ADDENDUM NO. 1  
TO THE CONTRACT DOCUMENTS  
FOR THE CONSTRUCTION OF THE  
VERNON HILLS NCT WRF PHASE 2 – 2017 IMPROVEMENTS  
LAKE COUNTY PUBLIC WORKS DEPARTMENT  
VERNON HILLS, ILLINOIS  
BID NUMBER #17013

**DATE: April 4, 2017**

# EQUIPMENT PAD

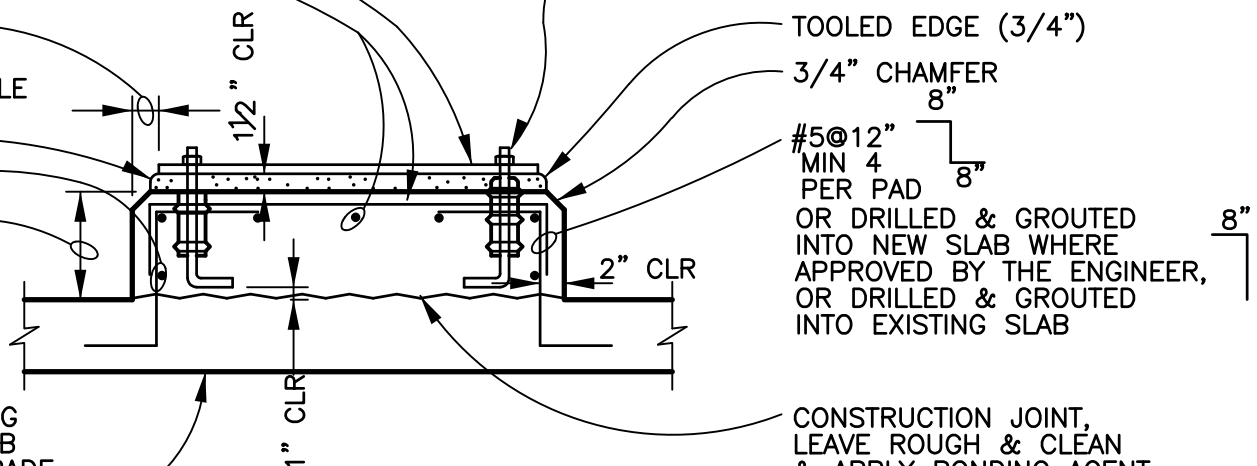
1. Add attached standard details 03601, 03602 and 03611 to the drawing.
2. Revise Roof Drain Detail 07502 by revising the note at the roof drain from “DRAIN BY MC” to “16” DIAMETER, LOW PROFILE DOME, BOTTOM OUTLET ROOF DRAIN WITH COMBINED FLASHING CLAMP AND GRAVEL STOP, CAST IRON BODY, NO HUB OUTLET, CAST IRON VANDAL PROOF DOME, EXTENSION COLLAR, UNDERDECK CLAMP AND SUMP RECEIVER, SIZE TO MATCH EXISTING, J.R. SMITH MODEL 1010 OR EQUAL.” Also revise note at the roof drain from “CLAMP RING BY MC” to “CLAMP RING”.
